IEEE802.3bt
LLDP adhoc

Meeting #8: Tuesday August 15, 2017
Rev001

- **The purpose** of this ad-hoc is to resolve LLDP state machine related comments from D2.4 and related issues for PSE and PDs prior sponsor ballot for D3.0.

Annex A: Why we need $Y=A+B$ as currently in the spec? -2

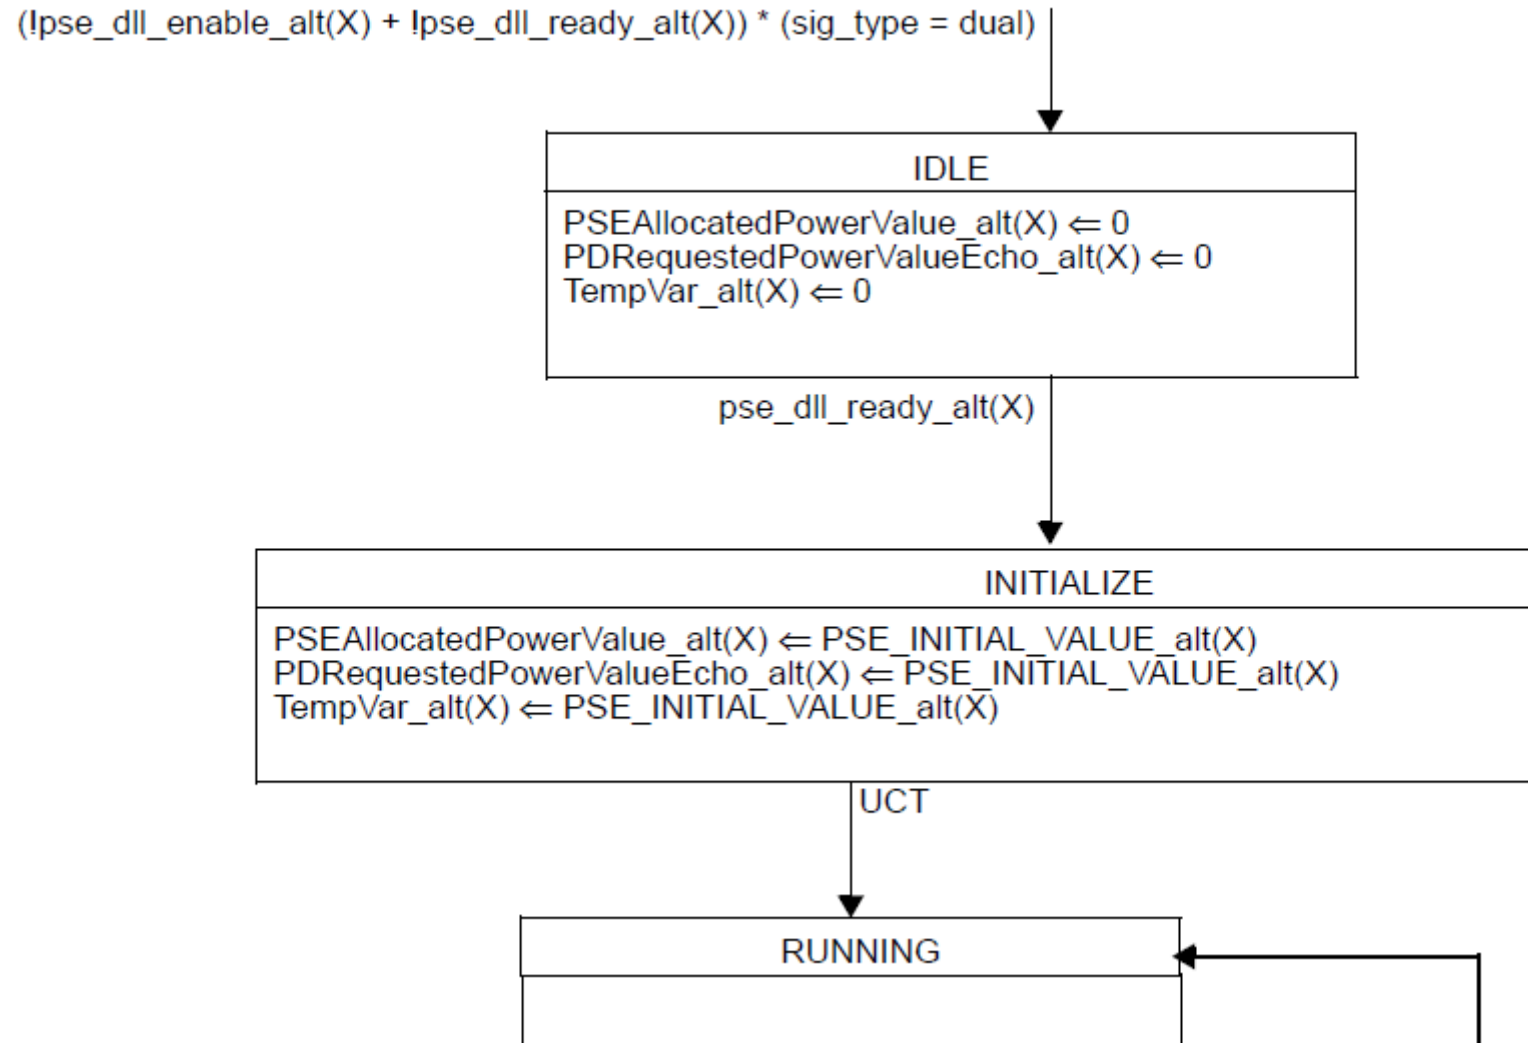
- Argument #3

High level power management care only for the total port power. The power management per pairset is kind of sublayer of the power management system. It is useful to pass the total power through the TLVs field. This is in general how current PSEs systems works.

Other alternative solution to this problem is to use the field “PSE max available power” which should be the total port power. We need to clarify in 79.3.2.6e that this value is applicable for PSE that supports single-signature and dual-signature.

Annex B: Comment #297 D2.4 (Page 75 line 12 in D2.5) - Figure 145-43

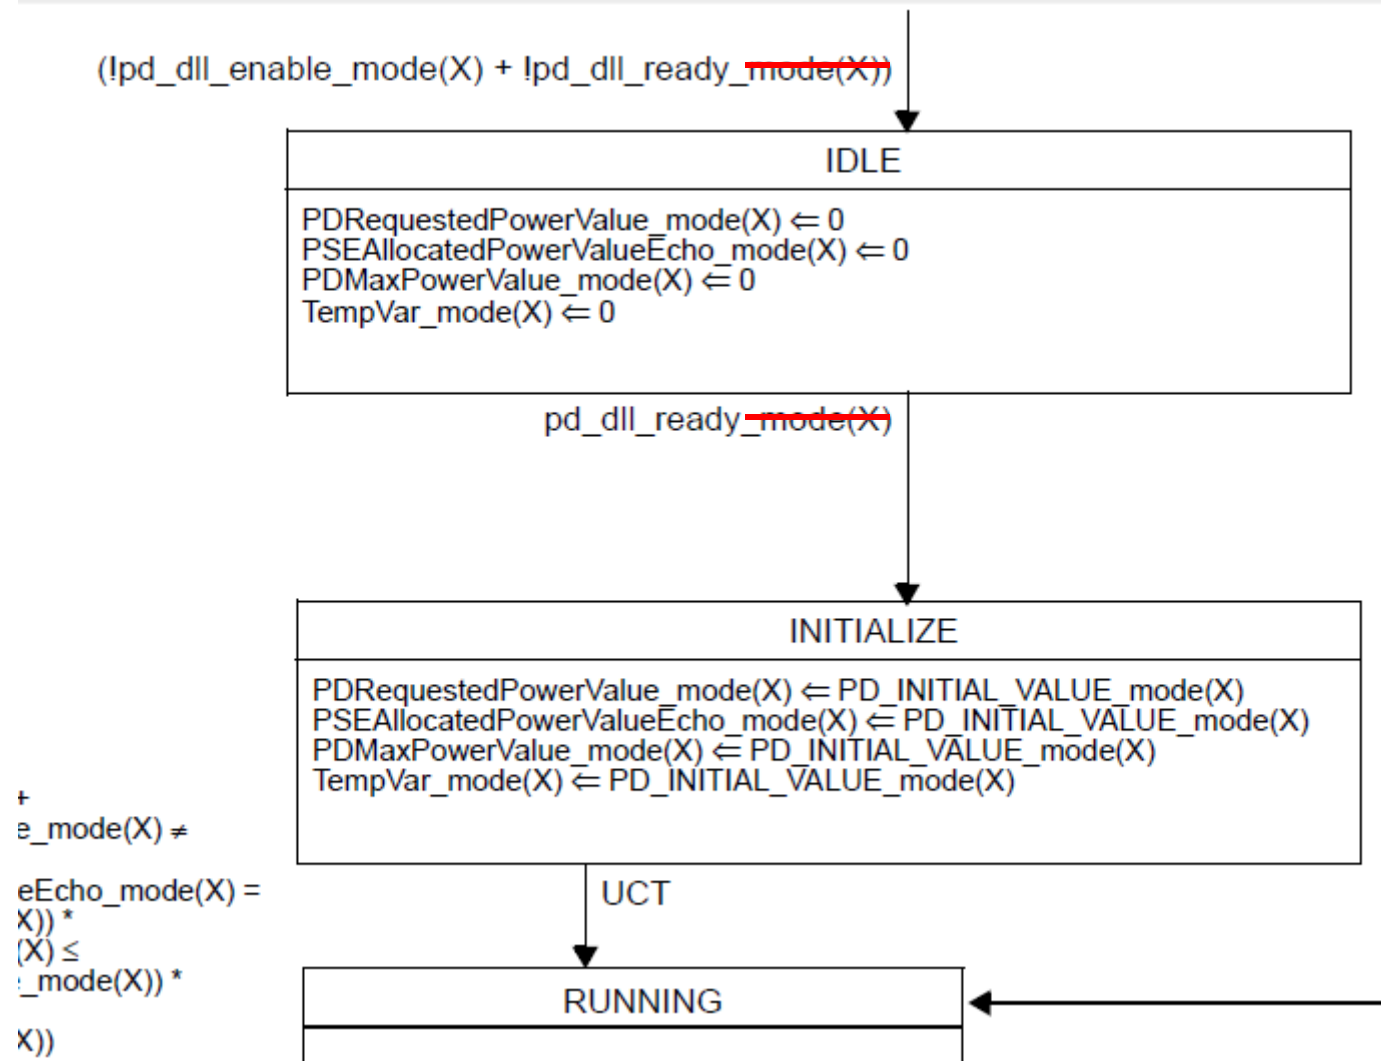
Annex B: Comment #297 D2.4 (Page 75 line 12 in D2.5) - Figure 145-44
 Proposal for a change marked in RED. Group is OK.

- Comment #297 D2.4 (D2.5 Page 78 line 46)

"If Mode (X) is non-active while the other mode is active, the inactive PD requested power value Mode (X) field value shall be set to 0."

- What is this trying to do ? The PD may wish to ask for power on an unpowered Mode...

Strike sentence.

- We have the information of total available power in the field “PSE maximum available power” in 79.3.2.6e. This resolve argument #2 in Annex A.
- To resolve #297, Lennart suggests: In order to request power on the unpowered pairset, see proposed changes in the red text. In addition, the `pd_dll_ready_mode(X)` need to be changed to `pd_dll_ready` to allow progressing to the INITIALIZE state in case PD want power on the unpowered pairset. No changes required in the PSE portion.

- Yair it will work:
- The proposal is:
 - To change from `pd_dll_ready_mode(X)` to `pd_dll_ready` in the PD state machine.
 - To change “if this mode/Alt is inactive, set to value 0” to “if this Alt is inactive, set to value 0” i.e. keep this requirement only to PSE.

- Group is OK.

- Lennart response: The proposed response to this comment is to adopt:
 - To change from pd_dll_ready_mode(X) to pd_dll_ready in the PD state machine.
 - To change “if this mode/Alt is inactive, set to value 0” to “if this Alt is inactive, set to value 0” i.e. keep this requirement only to PSE.
- **Group to discuss.**
- **GROUP OPINION? Group is OK.**
 - The modifications proposed to the state machine in Figure 145-43?
 - To change from pd_dll_ready_mode(X) to pd_dll_ready in the PD state machine.
 - To change “if this mode/Alt is inactive, set to value 0” to “if this Alt is inactive, set to value 0” i.e. keep this requirement only to PSE.
